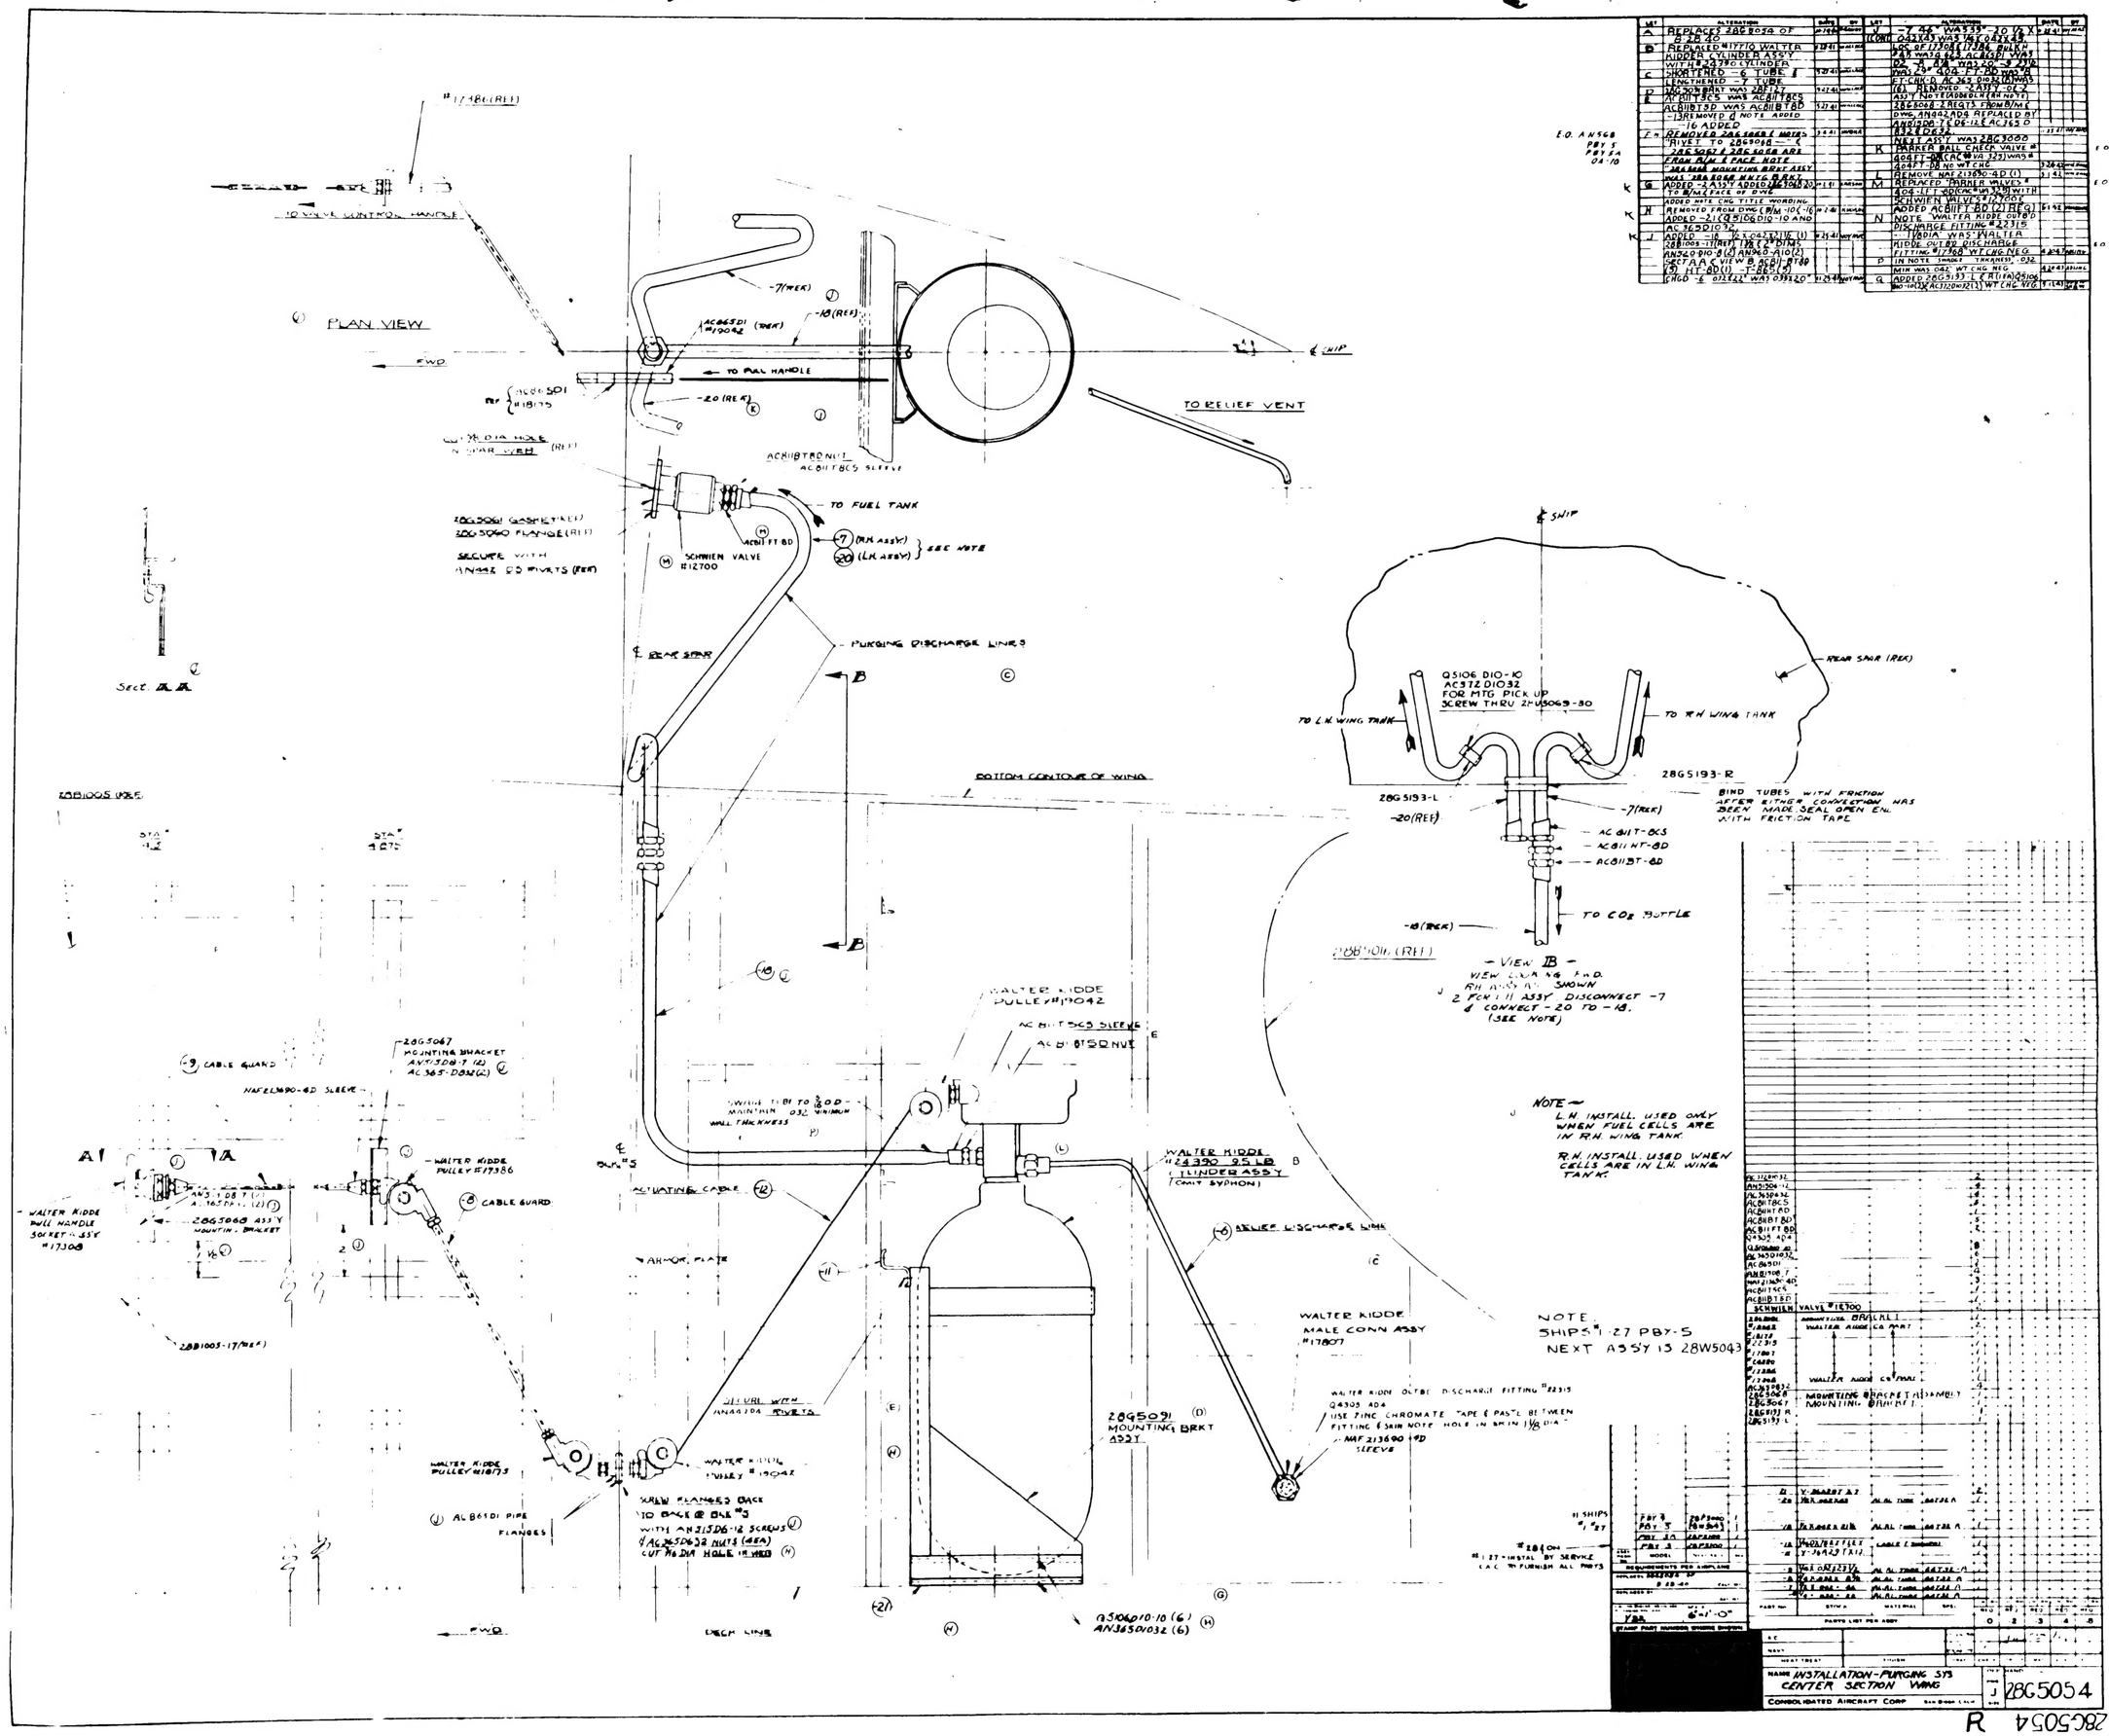
LET	ALTERATIONS	DATE	BY
A	REPLACED 28E8058 OF 6-28-40	7-28-40	
B	REPLACED #17710 WALTER KIDDER CYLINDER ASSY WITH #24390 CYLINDER	7-29-41	
C	SHORTENED -6 TUBE & LENGTHENED -7 TUBE	7-29-41	
D	MOD 205 PART WAS 28E1177 AC811T5CS WAS AC811T8CS AC811BT5D WAS AC811BT8D -13 REMOVED & NOTE ADDED -16 ADDED	9-22-41	
E	REMOVED 28G1068 & NOTES "RIVET TO 28G5068 — 6 28E5067 & 28G5068 ADD FROM B/M & FACE NOTE 28G5068 MOUNTING BRKT ASSY WAS 28B1005-17 REF	9-5-41	
F	ADDED -2 A357 ADDED AC365D1-20 TO B/M & FACE OF DWG	9-12-41	
G	ADDED NOTE CHG TITLE WORDING. REMOVED FROM DWG (B)M -10(-16 ADDED -21 (Q5106 D10-10 AND AC365D1032.	11-7-41	
H	ADDED -16 ½ COAT SYNC (1) 28B1005-17 (REF) 28B1005-17 (REF) 2 DIM. AN3420 910-8 (2) AN960-A10 (2) SECT AA & VIEW B AC811-8T8D (5) HT-8D (1) -7-28G1(2) CHGD -6 0.22222 WAS 0.3932"	9-25-41	
I	ADDED -16 ½ COAT SYNC (1) 28B1005-17 (REF) 28B1005-17 (REF) 2 DIM. AN3420 910-8 (2) AN960-A10 (2) SECT AA & VIEW B AC811-8T8D (5) HT-8D (1) -7-28G1(2) CHGD -6 0.22222 WAS 0.3932"	11-25-41

J	ADDED -16 ½ COAT SYNC (1) 28B1005-17 (REF) 28B1005-17 (REF) 2 DIM. AN3420 910-8 (2) AN960-A10 (2) SECT AA & VIEW B AC811-8T8D (5) HT-8D (1) -7-28G1(2) CHGD -6 0.22222 WAS 0.3932"	12-1-41

LET	ALTERATIONS	DATE	BY
J	-7 A357 WAS 3/8-10 UX X 5 (2)	12-1-41	
	(CONT) 0.42343 WAS 1/4 0.42343		
	DOC OF 1130-1 (1) 28G BULKH		
	7-21 WAS 7-23 AC8581 WAS		
	D2 -1 A28 WAS D2 -3 7/16		
	DWG 28-4004 7-7-210 WAS		
	E7-CHG'D AC 363 D10-12 DWG WAS		
	161 REMOVED -2 ASSY -D2-2		
	ASSY NOTE ADDED (AN NOTE)		
	28E6068-2 REQ'D FROM B/M &		
	DWG, AN442-AD5 REPLACED BY		
	AN960D8-7 & D2-1 & AC363 D		
	1324 DC932	12-27-41	
	NEW ASSY WAS 28G3000		
K	PARKER BALL CHECK VALVE # 404FT-8BK (AC # WA 325) WAS # 404FT-8B NO WT CHG	3-26-42	
L	REMOVE NAF 213690-4D (1)	3-31-42	
M	REPLACED PARKER VALVE # 404-FT-8D (AC # WA 325) WITH SCHWIEN VALVE # 12700		
	ADDED AC811T-8D (2) REQ	5-1-42	
N	NOTE WALTER KIDDE OUTBD DISCHARGE FITTING # 22315		
	-1 (2) DIA. WAS WALTER KIDDE OUTBD DISCHARGE FITTING # 17308 WT CHG NEG	4-24-42	
P	IN NOTE SHORT THREADS .032 MIN WAS .042 WT CHG NEG	4-24-42	
Q	ADDED 28G5193 (1) & AC1320W2(1) WT CHG NEG	11-14-42
